(PUD1901-02) Sheldon Crossing Phase 2 Final Development Plan, L&V Development Co., 3373 Busch Dr., is requesting final development plan approval for phase 2, on a parcel of land described as P.P. # 70-14-21-300-132, located at 3045 Port Sheldon St., Georgetown Township, Ottawa County, Michigan.

The request is for a final development plan approval for phase 2 of Sheldon Crossings 21.5 acres for 15 condominium buildings with a total of 34 units. The proposal calls for 7 acres of open space overall. The plan shows Meadowview Drive connecting from the west side of the property to the east side. The rest of the streets are proposed to be private.

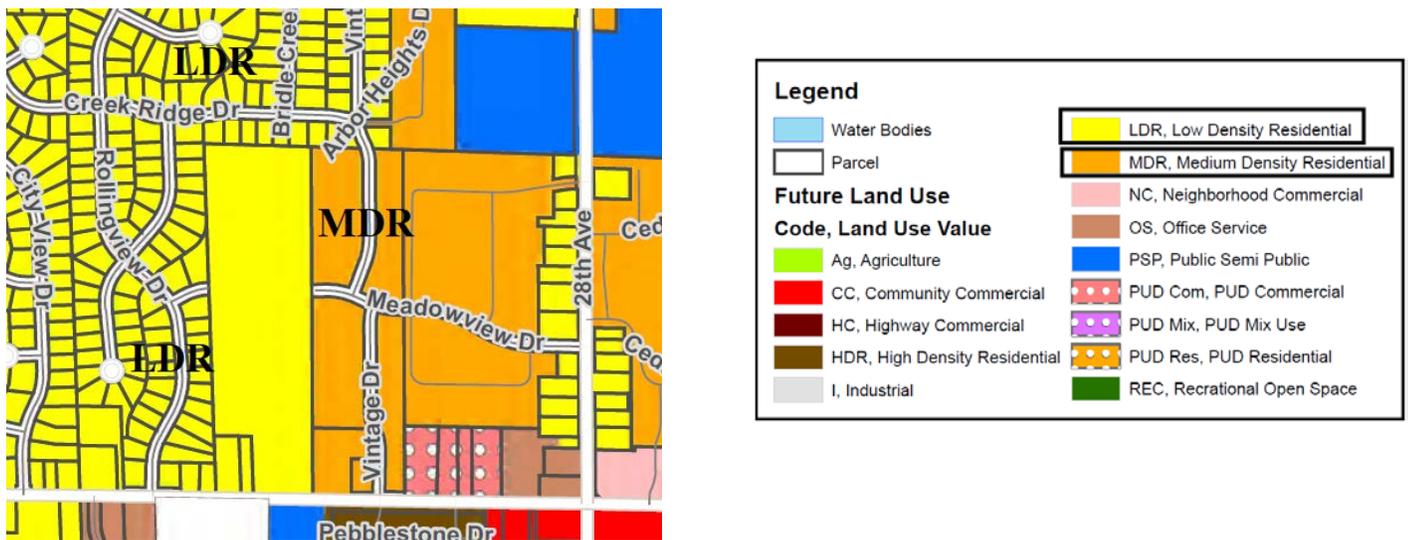
The proposal appears to be consistent with the text and Future Land Use Map in regard to the uses and the density. The Future Land Use Map shows the area as LDR. The plan proposes 3.3 units per acre which is close to being consistent with an overall density of 3 units per acre which meets the intention of page 36 in the Master Plan. Further, page 35 of the Master Plan states the following and the property to the east is designated Medium Density Residential.

It is noted that lines separating land use categories are NOT to be considered to be defined lines and the lines are not necessarily parcel specific.
